COMMUNITY DEVELOPMENT DEPARTMENT REPORT

HEARING DATE: 8/15/2024
TO: Planning & Zoning Commission
FROM: Sonya Allen, Associate Planner
208-884-5533
sallen@meridiancity.org

APPLICANT: Ball Ventures Ahlquist

SUBJECT: [H-2023-0071](#)
District at Ten Mile – CPAM, MDA,
RZ, PP

C. Future Land Use Map – Adopted vs. Proposed

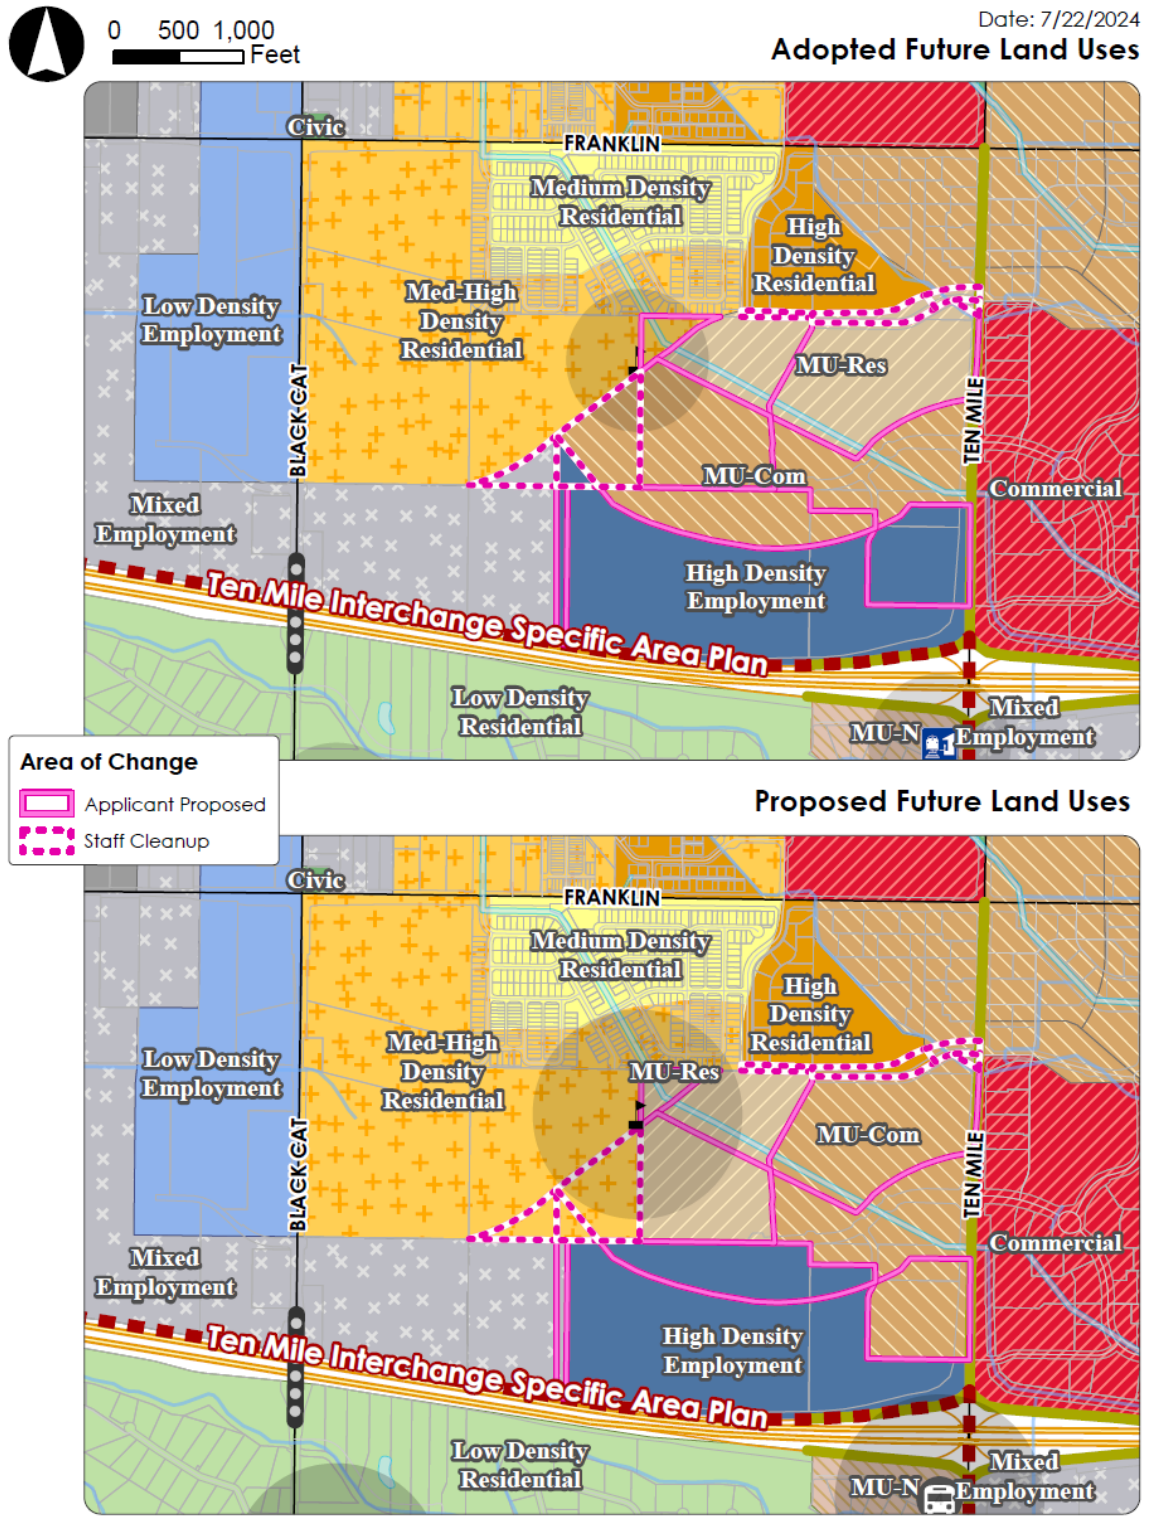
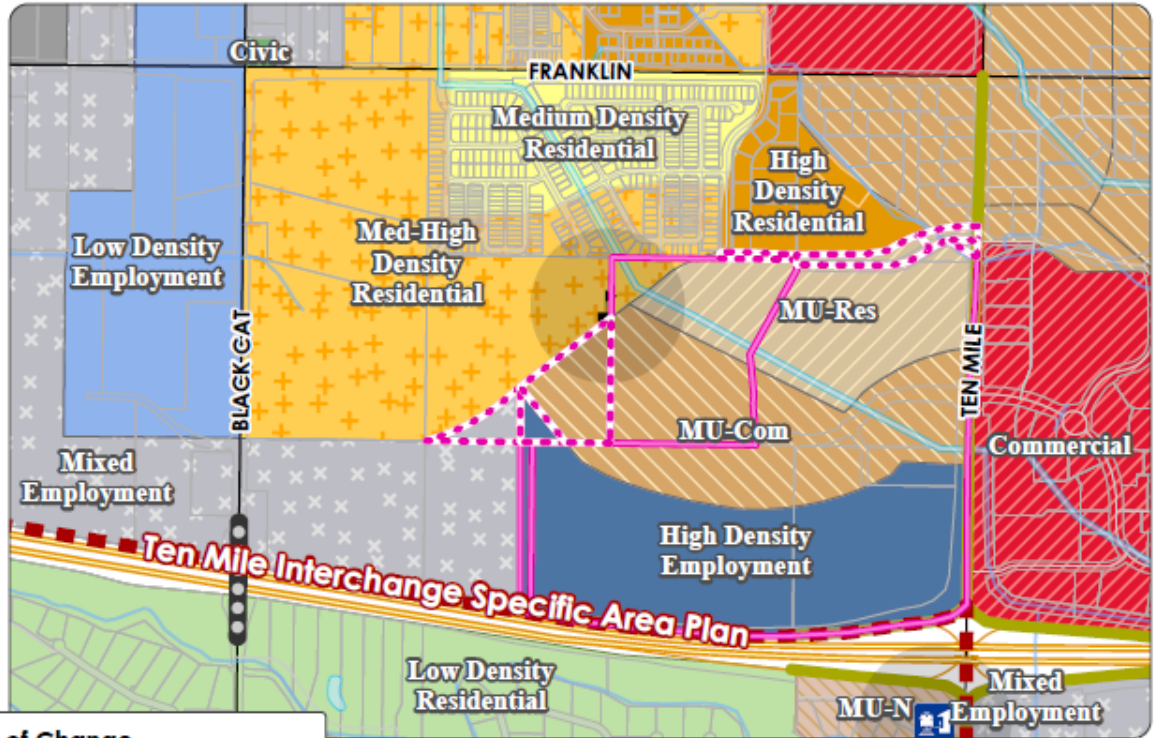
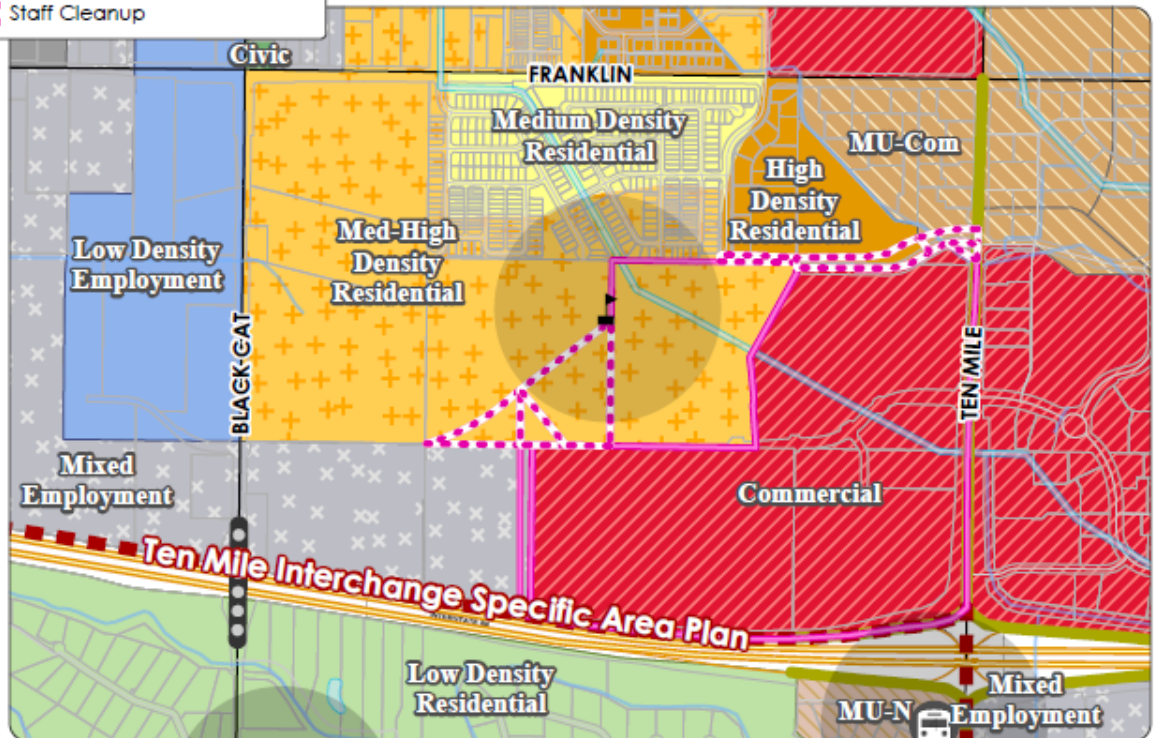
In summary, Staff is *not* in support of the proposed map amendment and associated rezone based on the conceptual development plan proposed as it doesn’t meet the *minimum* development guidelines in the TMISAP nor does it provide the mix of *integrated* uses desired in Mixed Use designated areas or the intensity and/or types of uses desired in the MU-Com and HDE designated areas.

If Council is of the opinion the proposed development plan is more appropriate for this area than that envisioned in the adopted TMISAP, Staff suggests alternate FLUM designations and zoning are approved consistent with the proposed development plan, as follows: MHDR and R-15 zoning for the property in Area 1; and Commercial and C-G zoning in Areas 2 and 3 (see second adopted vs. proposed FLUM exhibit in Section VII.C).

If City Council is in favor of the proposed development plan, Staff suggests changes to the FLUM and associated zoning to coincide with the proposed plan (i.e. Area 1 – MHDR FLUM designation with R-15 zoning; Areas 2 & 3 – Commercial FLUM designation with C-G zoning) and the following development agreement provisions and conditions of approval: *If Council is not in favor of the proposed development plan, Staff recommends denial of the MDA, CPAM and RZ applications and striking the following DA provisions and conditions.*

H. Use Area Plan

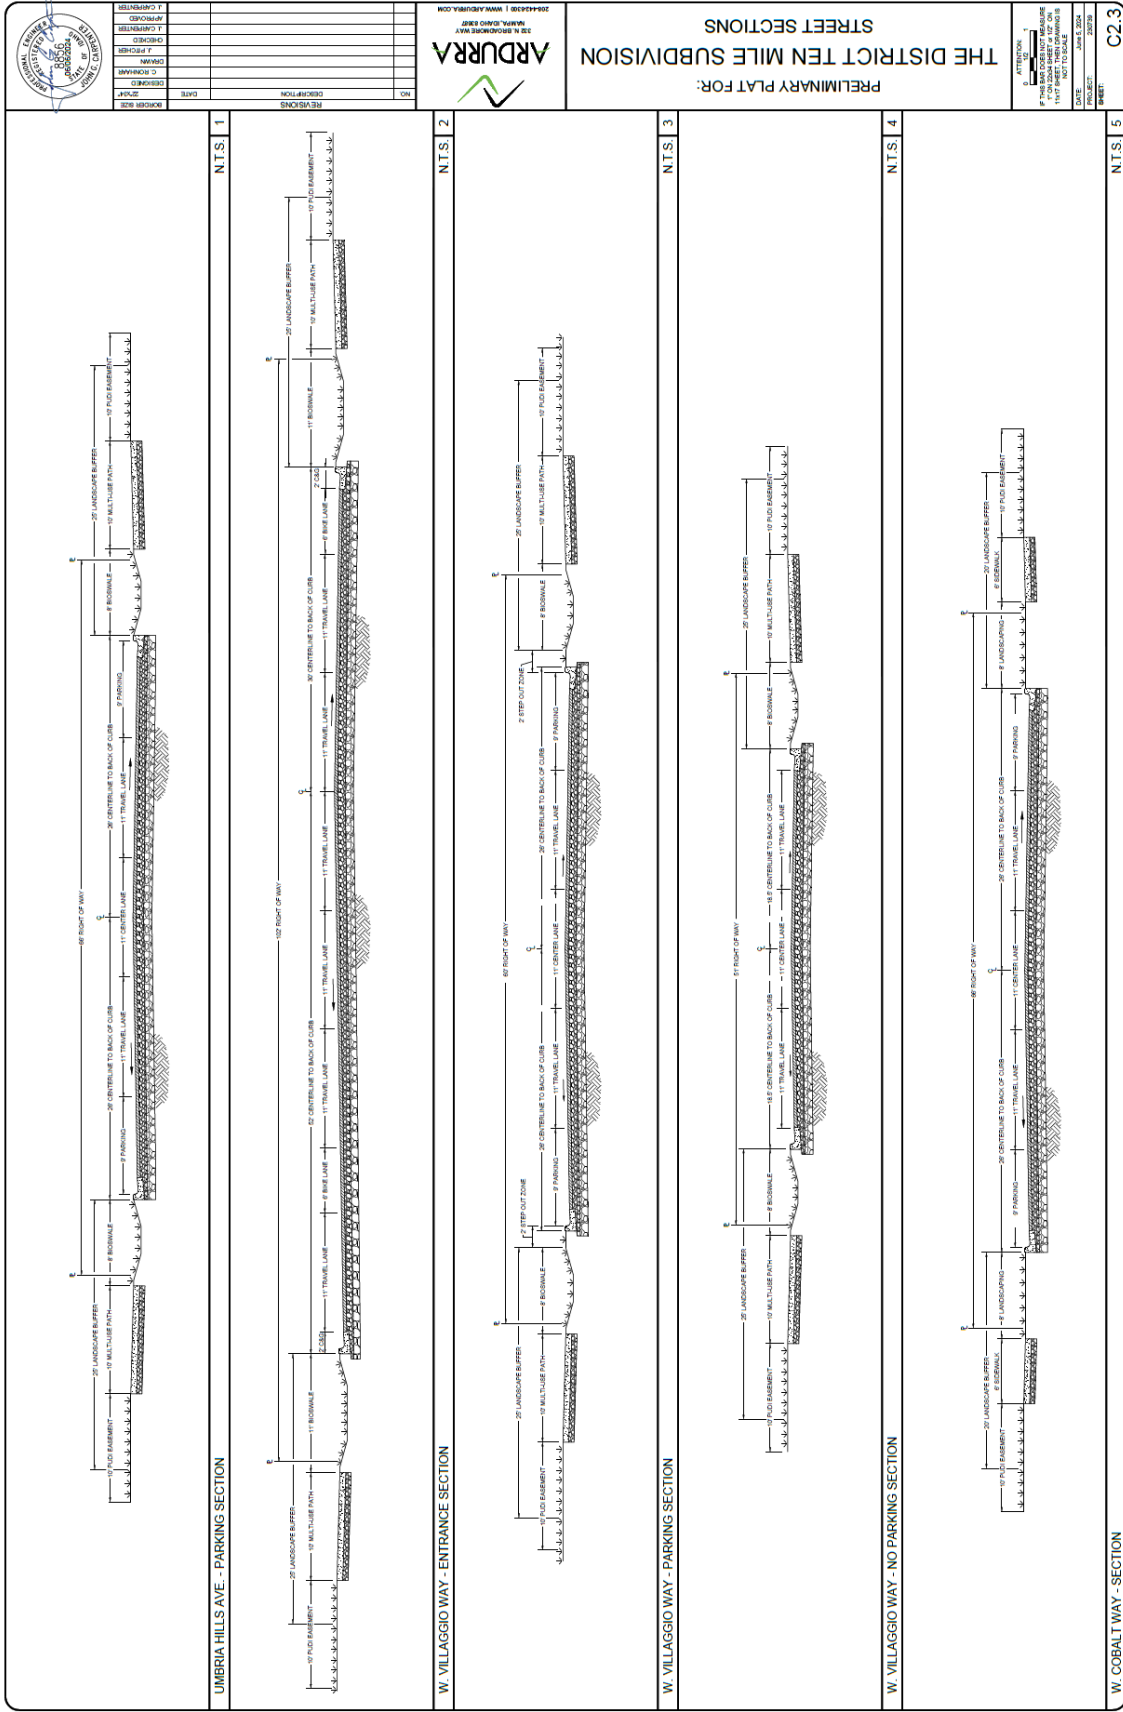
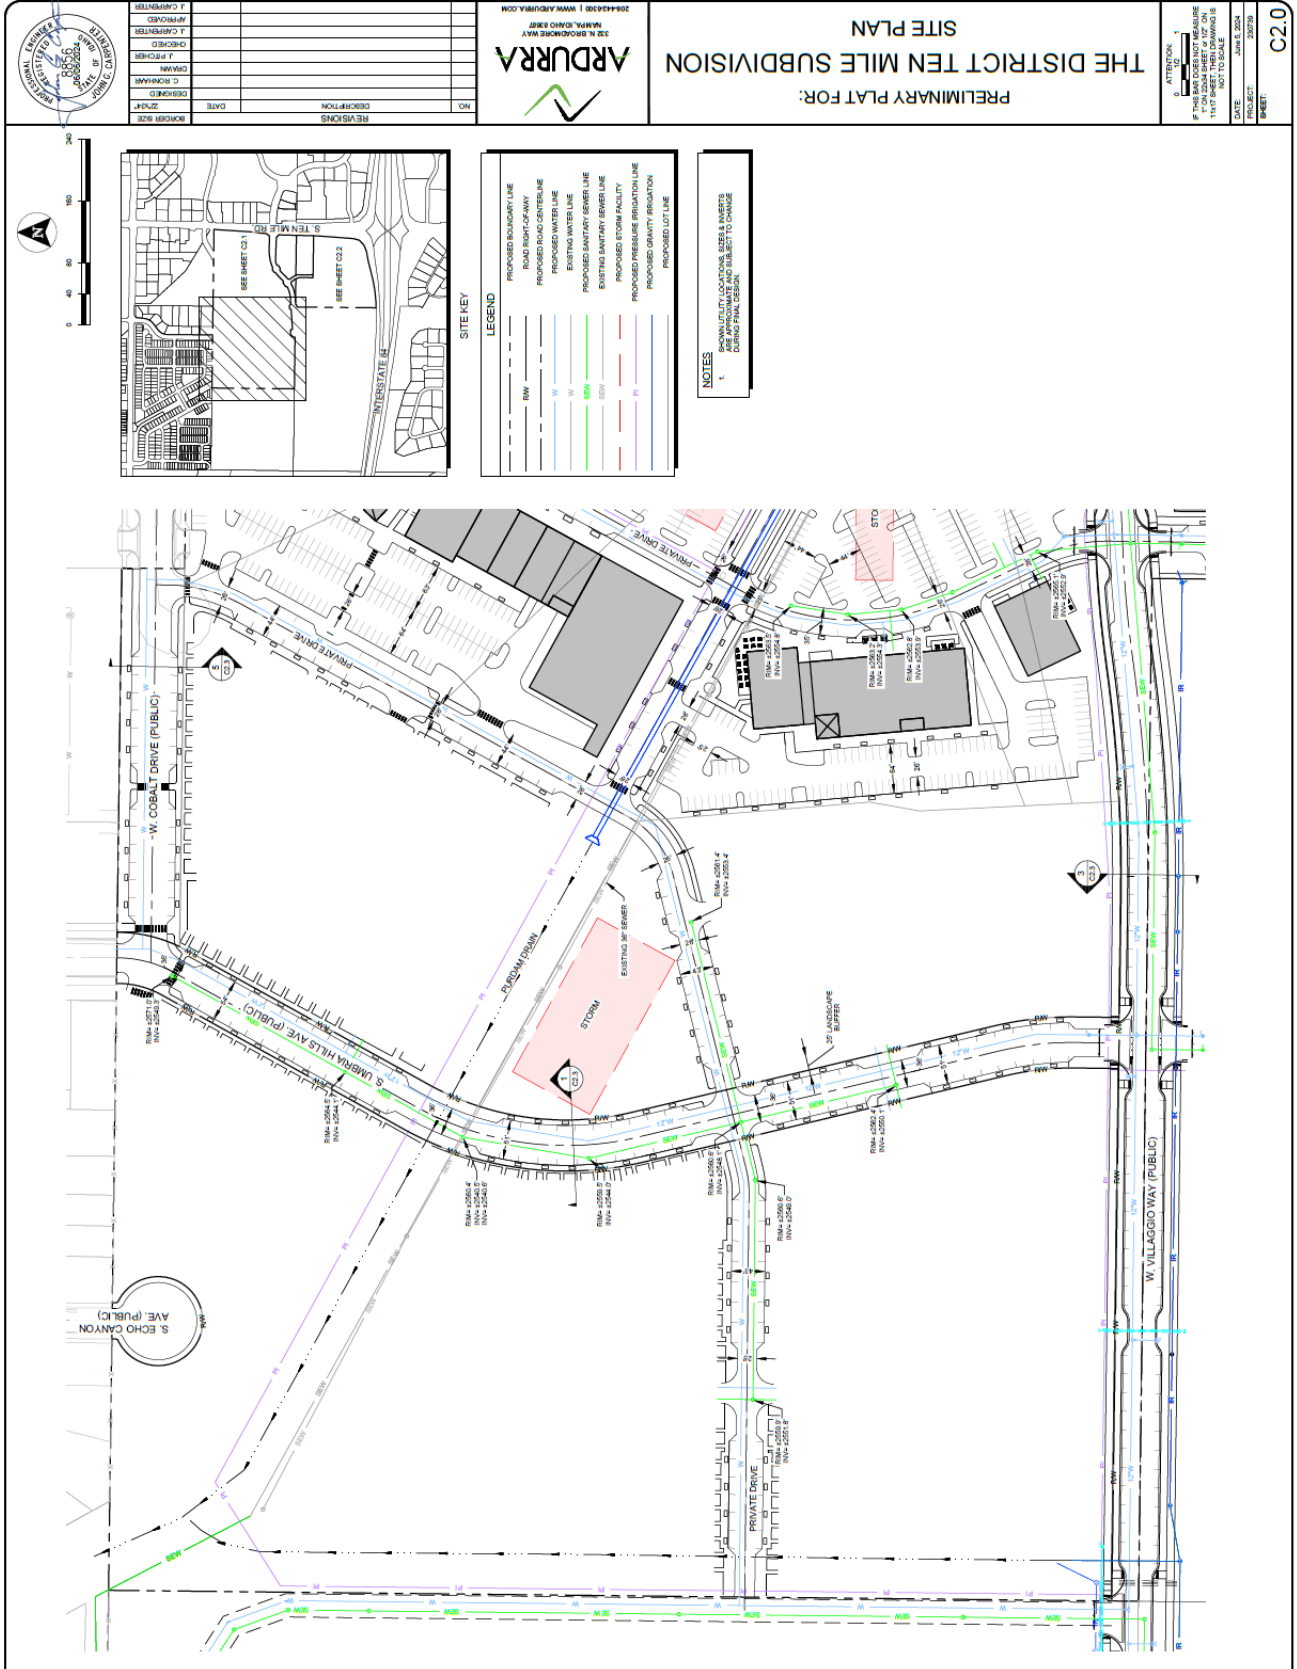
A Use Area Plan was submitted with this application and included below in Section VI.H. The Plan depicts three (3) different areas; however, the boundaries of these areas do not coincide with the proposed FLUM designation boundaries, which makes determining consistency with the FLUM designations difficult. These areas are as follows:

Only residential uses are proposed in the requested MU-Res FLUM designation and TN-C zoning district – the “mixed-use” component of the designation and TN-C district is entirely missing. Only one of the three major use categories are proposed (i.e. residential) – no retail, office or employment uses are proposed as required, which are essential in MU-Res designated areas. The proposed MU-Res designation and TN-C zoning is not consistent with the proposed development plan or the intended plan for this area as the required mix of integrated uses is not provided.

Although a mix of commercial uses are proposed, only one of the three major use categories is provided (i.e. commercial) – no major employment uses are proposed as required in either the MU-Com or the HDE areas and integrated residential uses are not proposed in the MU-Com area, which are essential. The proposed MU-Com and HDE designations are *not* consistent with the proposed development plan or the intended plan for this area as the required mix of uses is not provided – significant changes to the concept plan and use area plan would be needed in order to be consistent.

See above for information on MU-Com and HDE designated areas and associated analysis. **As noted above, the FAR’s in the MU-Com and HDE areas are *significantly* below the established goals in the Plan. Although commercial and employment uses are proposed from the three (3) major use categories, integration of residential uses is not proposed as desired. Office and other employment uses need to be of a much higher intensity in this area in order to be consistent with the MU-Com and especially the HDE designation and designed as compact urban centers rather than lower density suburban-style development Recreation uses are not desired in HDE designated areas.**

- ii. Future development of Area 1, as depicted on the Use Area Plan in Section VI.H, shall be consistent with the development guidelines of the Medium High Density Residential Future Land Use Map designation in the TMISAP.

- iii. Future development of Areas 2 and 3, as depicted on the Use Area Plan in Section VI.H, shall be consistent with the Commercial Future Land Use Map designation in the Comprehensive Plan.
